Clean up of Off-Site Contamination
Findlay Property

Enclosed are responses to your comments to Final Radiological Status Report (Findlay Property). If upon review, additional clarification is required, please contact me.

U.S. NUCLEAR REGULATORY COMMISSIONS STAFF REVIEW
"RADIOLOGICAL STATUS REPORT FOR THE
REMOVAL ACTION CONDUCTED ALONG
THE NORTHERN BOUNDARY OF THE MOLYCORP INC. PROPERTY
WASHINGTON, PENNSYLVANIA"

Figure 1

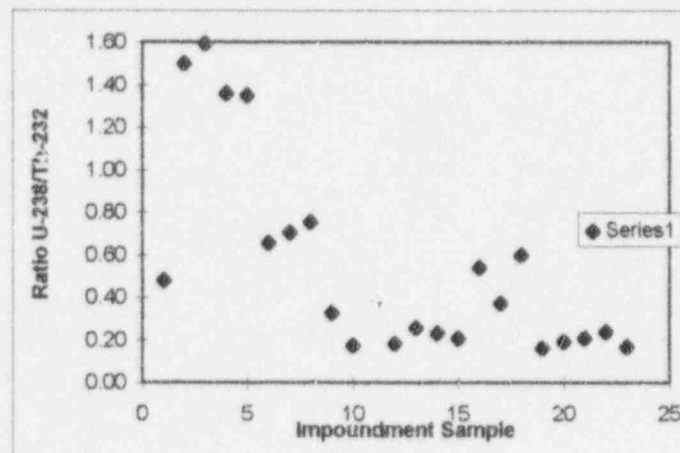
The statement that: (1) "it was discovered that uranium is equilibrium with its daughters was also present and indeed the principal decay chain series:" and (2) "the source of the uranium and uranium decay chain radionuclides is unknown at this time. " need to be discussed in light of the concentration of uranium and daughters that were found during site characterization and the concentrations that were present in the original ore that was processed. The report should state the contribution, if any, that operations on the Findlay property contributed, or could have contributed to these concentrations.

The statement "the source of the uranium and uranium decay chain radionuclides is unknown at this time" requires clarification. The source of the uranium and uranium decay chain radionuclides is likely an ore processed at the Molycorp facility processed by Molycorp or its' predecessor company. However no data is known to exist as to the constituency regarding the original ore or the product.

A review of the data presented in the Site Characterization Report (SCR) and the Impoundment Closure Plan indicates the following. Uranium in the input ore (from the

Araxa mine) ranged from 0.04% to 0.06% by weight (page 5-1 SCR) while the thorium concentration ranged from 1.87% to 2.08 %. The average ratio of the concentration of uranium to thorium is approximately $1/4000$ (0.25×10^{-3}). This is contrasted with samples from the thorium pile, the impoundment closure and the Findlay remediation. Table 5-5 (page 5-9 SCR) indicates the ratio of uranium series radionuclides (thorium-230) to the thorium series in the waste slag found in the thorium pile ranges from 0.071 to 0.30, a higher ratio than the source ore. This ratio indicates above background concentration of uranium. This is further corroborated by samples from the impoundment closure (see table 1). As is exhibited in the table, some samples indicate uranium series radionuclides in concentrations greater than the thorium series. The range for this ratio is 0.17 to 1.59. Table 2 present the ratio of uranium to thorium concentrations for the material placed in the rolloffs (see also Figure 1). As is indicated, the range of this ratio varies between 0.2 and 6.1. Thus in both instances the concentration of uranium is greater than the concentration of thorium. This is contrary to what would be expected from the input or source ore data.

The conclusion is that while the source of uranium concentrations in samples greater than the thorium concentrations is unknown, it can be assumed that other ores were processed which would give rise to these ratios. As stated this could have occurred under the predecessor firm or prior to the need for licensing i.e. the 1940's or earlier.
